# RENESAS TECHNICAL UPDATE

Product Category	MPU/MCU		Document No.	TN-SH7-A920A/E	Rev.	1.00
Title	Notes about SSCG		Information Category	Technical Notification		
Applicable Product	See following	Lot No.	Reference Document	See following		
		All

In the products listed in bellow, a bug about SSCG function is found. There is a possibility that SSCG function can not modulate clock frequency properly.

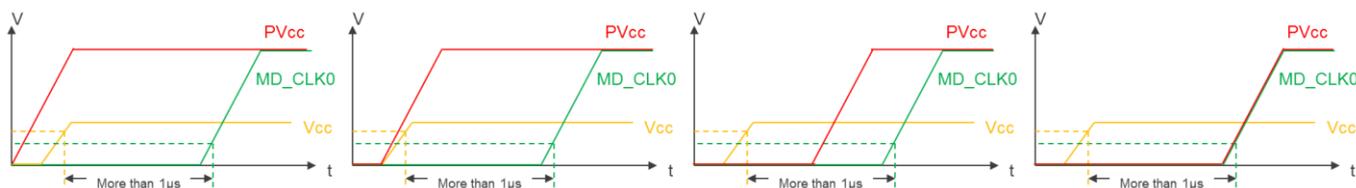
- Please make more than one microsecond between Vcc power on and change timing of MD\_CLK0 pin to high level. (below figure)

- PVcc power on timing should be at the same time as MD\_CLK0 pin or faster than MD\_CLK0 pin. (below figure)

if PVcc power on timing is later than change timing of MD\_CLK0 pin to high level, it becomes absolute maximum rating violation.

[4] Detail Condition

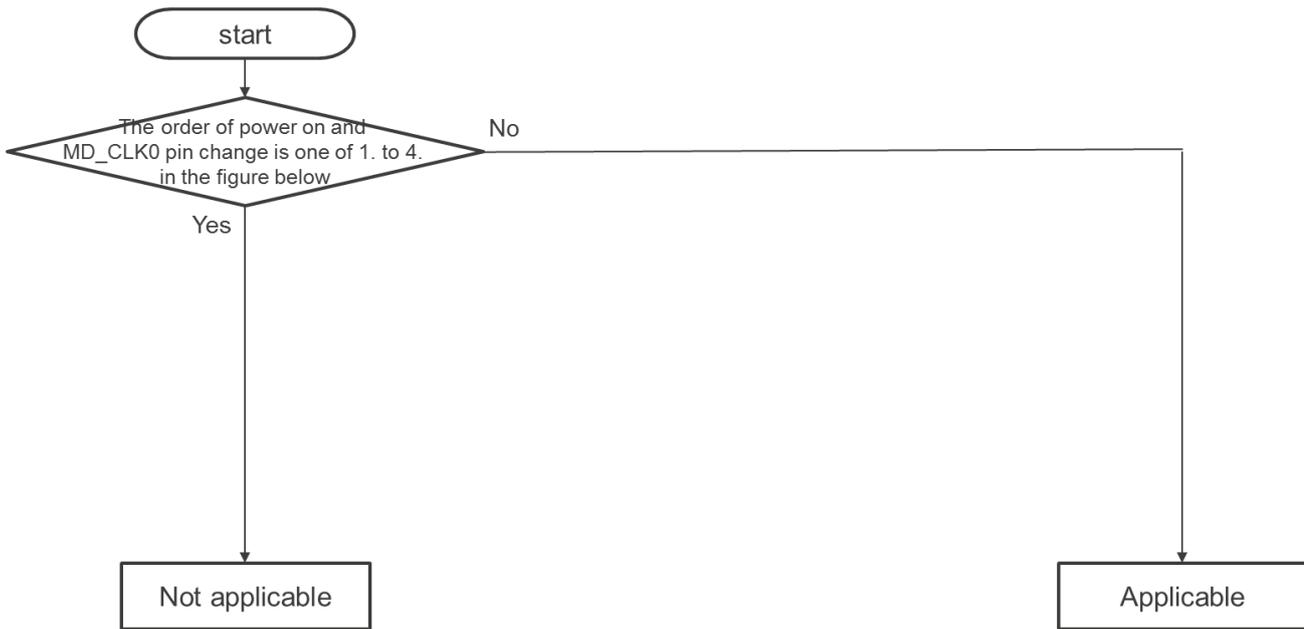
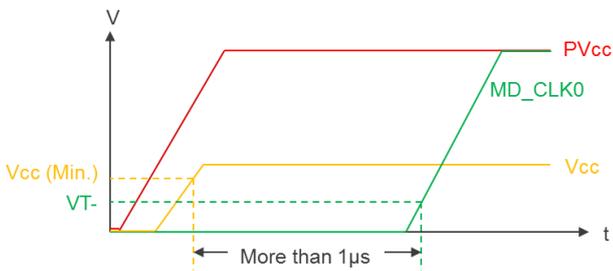
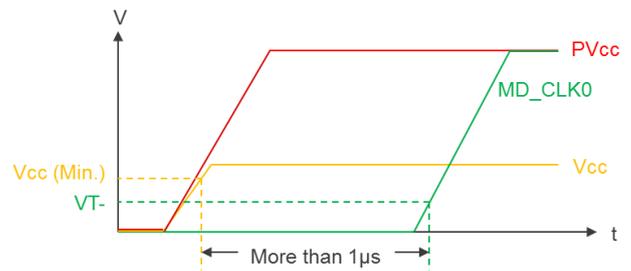
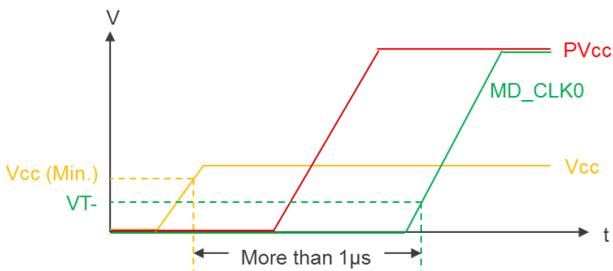
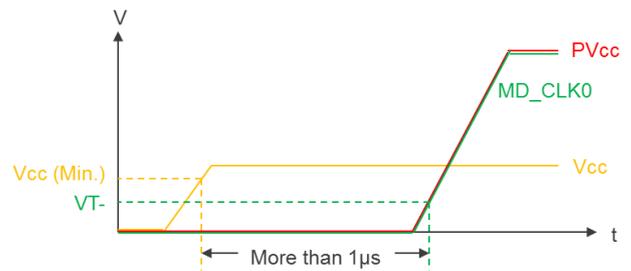
1. In case of order of PVcc, Vcc, MD\_CLK0

2. In case of order of PVcc = Vcc, MD\_CLK0

3. In case of order of Vcc, PVcc, MD\_CLK0

4. In case of order of Vcc, PVcc = MD\_CLK0

From Electrical Characteristics (DC) in  
 - SH7268 Group, SH7269 Group  
 User's Manual: Hardware  
 Vcc (Min.) = 1.15V  
 VT- = 0.5V

[5] Software workarounds details

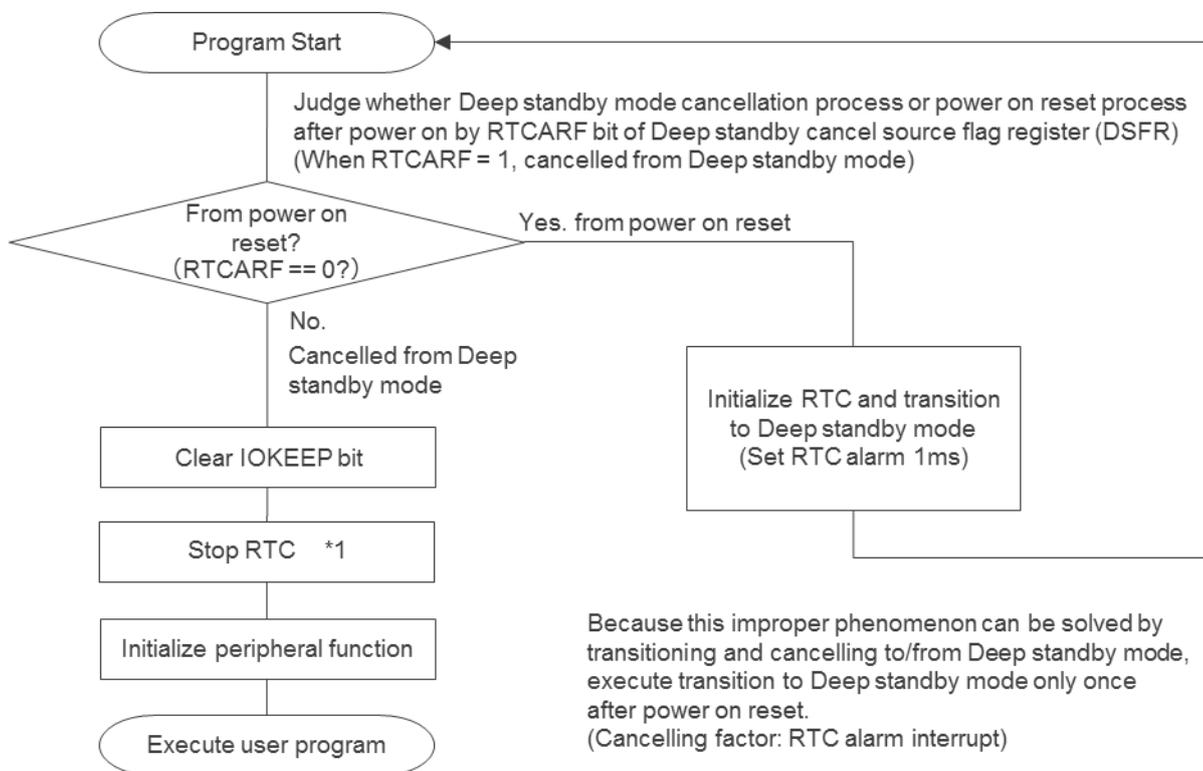
According to flowchart below, after power on, be sure to execute transition to Deep standby mode and cancelling, then execute user program.

\*1: Please execute depending on system

Only when selecting EXTAL as RTC operation clock, the frequency of the operation clock for performing the one-second counting operation can be set by Frequency register H / L (RFRH / L).

In this case, by setting the value of RFRH / L register according to the following formula, RTC alarm interrupt can be generated in less than 1s.

$$RFRH/L.RFC[18:0] = \text{Alarm interrupt time} \div (\text{EXTAL period} \times 64)$$

(in case of RFRH/L.SEL64 = 1)

e.g.) When EXTAL frequency is 13.33MHz, RFC[18:0]=209
